**CERTIFICATE OF APPROPRIATENESS**

**Property:** 4624 Norhill Blvd, Lot 7, Block 114, North Norhill Subdivision. The property includes a historic 1,416 square foot, one-story wood frame single-family residence and detached garage situated on a 5,000 square foot (50' x 100') interior lot.

**Proposal:** Alteration – Remove a flat metal roof over any existing porch measuring 12' wide by 20' deep and construct a new hip roof over the porch that will tie into the existing hip roof of the contributing residence. The roof will feature a 6-over-12 pitch to match the existing roof and the porch will have an eave height of 10'-4" to match the existing residence.

**SOUTH SIDE ELEVATION**

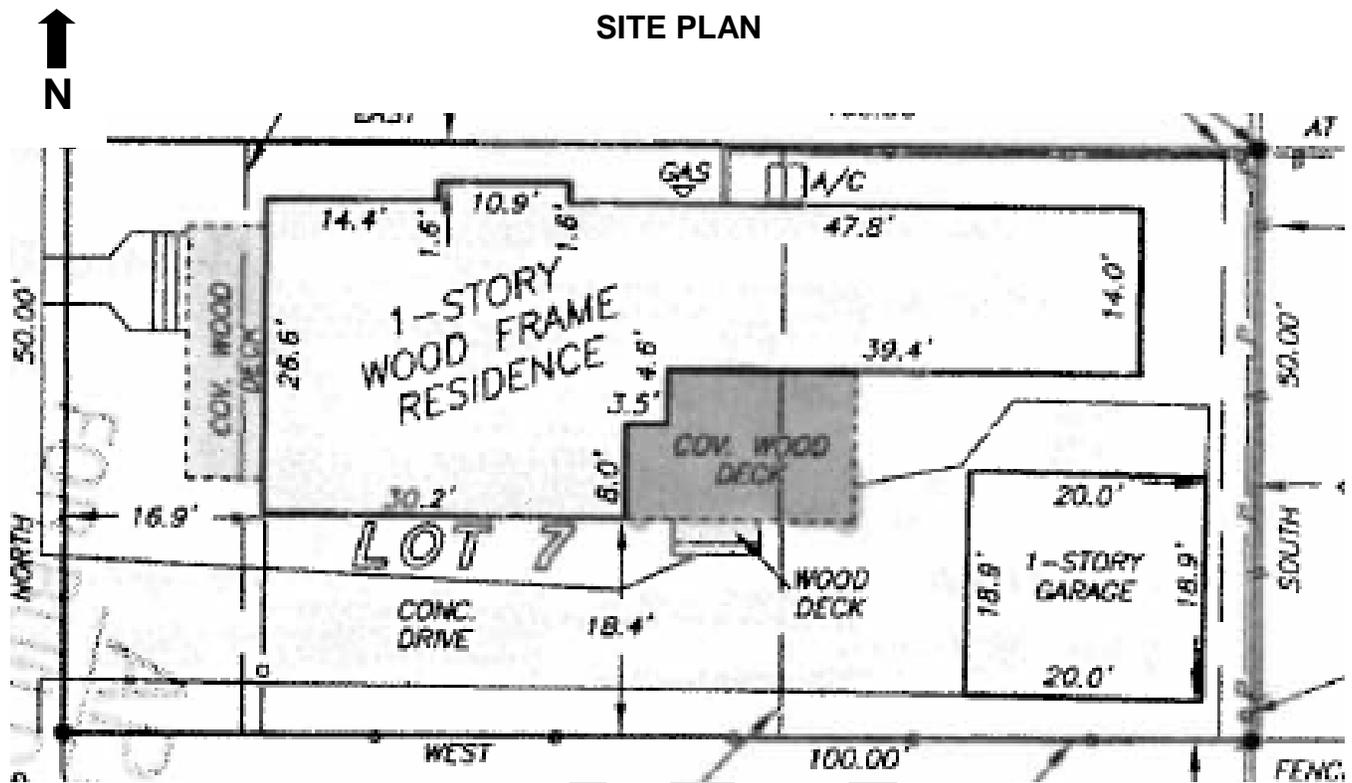
**Shape/Mass:** The residence features a covered porch on the south elevation measuring 20' wide and 12' deep. The porch will be removed and a new porch will be built on the same footprint measuring 20' wide and 12' deep. The porch will have an eave height of 10'-4".

**Recommendation:** Approval

ROOF PLAN

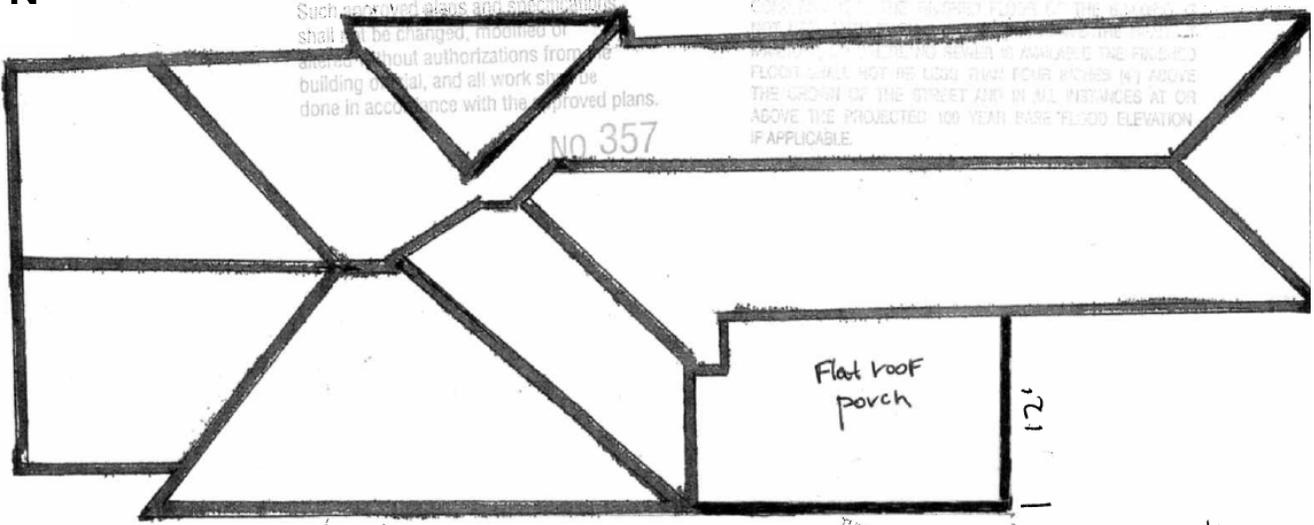
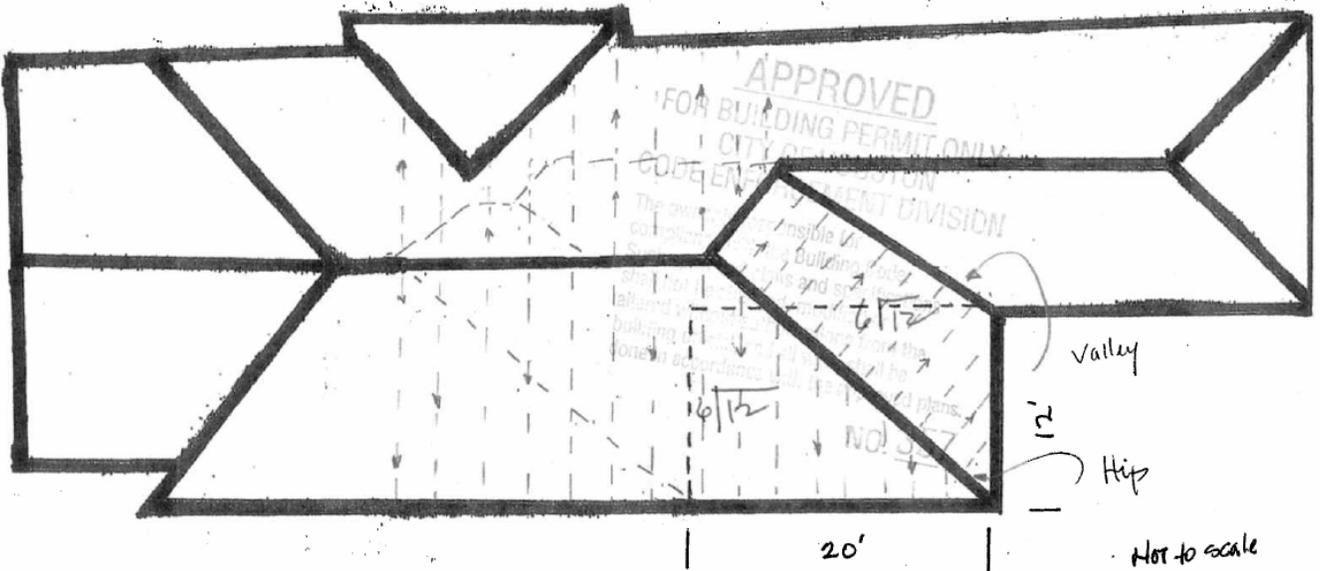
**Roof:** The residence features a gable on hip roof with a 6/12 pitch and the porch features a flat metal roof. The flat roof will be removed and replaced with a hip roof. The proposed roof will tie into the existing hip roof and will feature a 6/12 pitch to match the existing roof. The roof will be clad with composite shingles.
